5. COA-050743-2019

Commission of Architectural Review

STAFF REPORT

Amend previously approved plans to alter the porch enclosure and garage.

Figure 13. Previously approved elevation with faux railing on the second story, original connector between house and porch enclosure, and garage elevation. The rear elevation second story porch and the partial brick parapet wall on the garage were not approved.

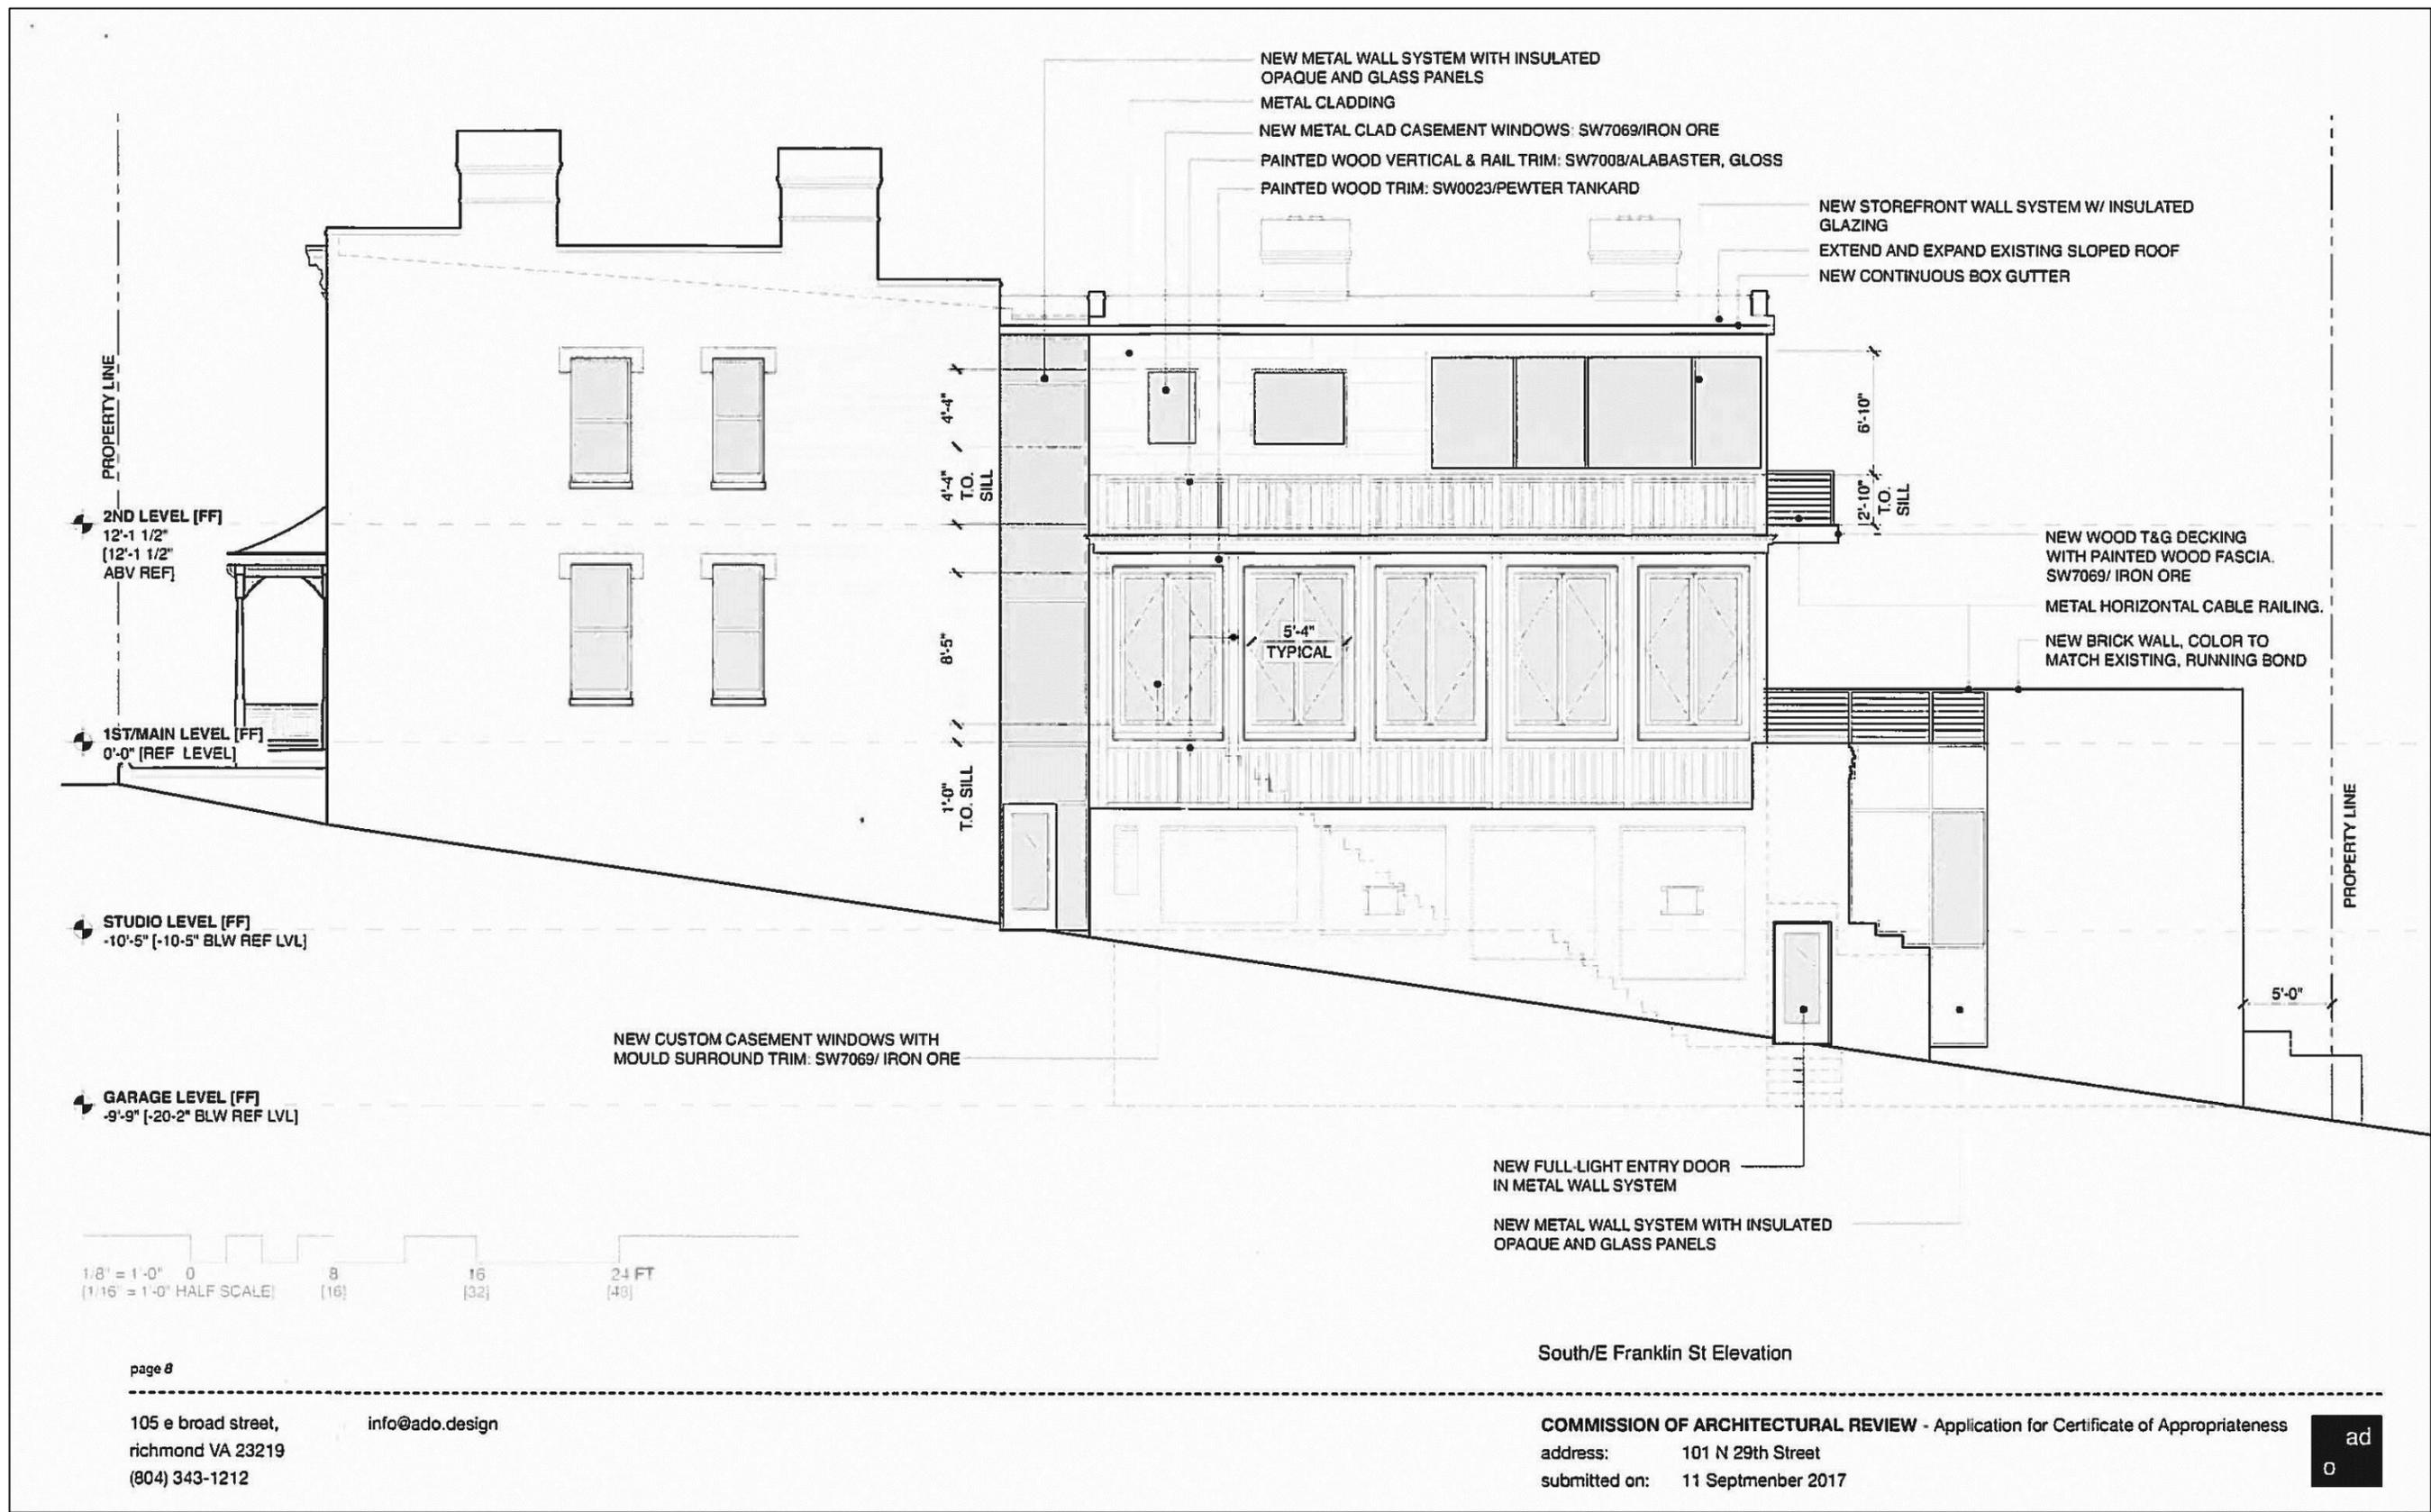
- The faux railing on the second story.
- The large glass panels on the connector between the main house and the porch enclosure.

- A high brick parapet wall on the garage addition. Staff recommends that the requested brick parapet wall be lowered to align with the height of the first floor level, that a small brick base for the end column be incorporated into the plans, and that if a railing is required it be a cable railing as originally approved by the Commission at the September 2017 meeting.

Staff recommends that the faux railing detail originally approved by the Commission be retained. Staff finds that this element reflects the historic two-story porch as seen in the early Sanborn maps and historic photographs. Staff finds that the railing also helps to break up the massing of the second story enclosure.

Staff has identified a change in plans for the connector between the primary mass of the building and the new porch enclosure. The original approval included a metal wall system with opaque and glass panels. The applicant now proposes to utilize a casement window with a new siding material. Historic photographs and maps indicate that this area was originally open as part of the historic porch. Staff recommends denial of this request to use large casement windows and instead recommends the large glass panel openings originally approved by the Commission.

Staff looked at historic photographs and determined that the parapet wall was originally approximately three feet above the porch deck and the end column sat on a small brick base. Staff recommends that the requested brick parapet wall be lowered to align with the height of the first floor level, that a small brick base for the end column be incorporated into the plans, and that if a railing is required it be a cable railing to emphasize that it is new construction, as originally approved by the Commission at the September 2017 meeting.
